UNITED STATES PATENT AND TRADEMARK OFFICE

APPLICATION NO.	FILING DATE	FIRST NAMED INVENTOR	ATTORNEY DOCKET NO.	CONFIRMATION NO.
10/583,607	06/20/2006	Jun Nishikawa	09812.0098	2625
22852	7590	02/02/2011	EXAMINER	
FINNEGAN, HENDERSON, FARABOW, GARRETT & DUNNER LLP 901 NEW YORK AVENUE, NW WASHINGTON, DC 20001-4413			JOHNSTON, PHILLIP A	
			ART UNIT	PAPER NUMBER
			2881	
			MAIL DATE	DELIVERY MODE
			02/02/2011	PAPER

Office Action Summary

Detailed Action

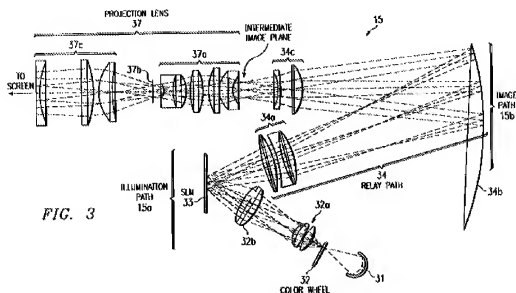
The examiner disagrees, because as interpreted from Figure 3 in Davis, the first optical system can include lens set 34a, concave mirror 34b and lens set 34c, which forms an intermediate image at the intermediate image plane, while the second optical system also includes concave mirror 34b and the components of Projection Lens 37, which are used to form a secondary image on a screen (the secondary image surface).

It is important to point out here that one of ordinary skill in the art recognizes that each of the first and second optical systems above are defined by the collection of optical elements used in a particular configuration, and would include sharing certain elements between them such as a common mirror in order to provide a folded light path.

5. Regarding claim 14, Davis discloses at Col. 3, line 38-67; and Col. 4, line 1-33; the projection display apparatus shown below in Figure 3 that includes the following;

(c) A first optical system that includes the following optical elements; lens set 34a, concave mirror 34b and lens set 34c, which forms an intermediate image of SLM 33 (the primary image surface) at the intermediate image plane, of lenses 34a as shown in Figure 3 above. Col. 4, line 16-33,

(d) A second optical system that also utilizes concave mirror 34b and the optical elements of Projection Lens 37 (note Figure 3 above) to create an image on the display system screen (the secondary image surface). Col. 4, line 16-33,

(e) An optical path represented by the three ray bundles shown in Figure 3 above, which reflect from the center and extremities of modulator SLM 33 (the primary imaging surface Col. 1, line 27-43), where the light first crosses the optical axis in light path 34 then reflects off the concave mirror 34b and crosses the optical axis again at the intermediate image plane then travels through the projection optics to the screen (the secondary image surface). See Col. 3, line 38-67; and Col. 4, line 1-33.

Davis discloses a projection display apparatus shown above in Figure 3 that includes the following:

(c) A first optical system that includes the following optical elements; lens set 34a, concave mirror 34b and lens set 34c, which forms an intermediate image of SLM 33 (the primary image surface) at the intermediate image plane, of lenses 34a as shown in Figure 3 above. Col. 4, line 16-33,

(d) A second optical system that also utilizes concave mirror 34b and the optical elements of Projection Lens 37 (note Figure 3 above) to create an image on the display system screen (the secondary image surface). Col. 4, line 16-33,

(c) An optical path represented by the three ray bundles shown in Figure 3 above, which reflect from the center and extremities of modulator SLM 33 (the primary imaging surface Col. 1, line 27-43), where the light first crosses the optical axis in light path 34 then reflects off the concave mirror 34b and crosses the optical axis again at the intermediate image plane then travels through the projection optics to the screen (the secondary image surface). See Col. 3, line 38-67; and Col. 4, line 1-33.
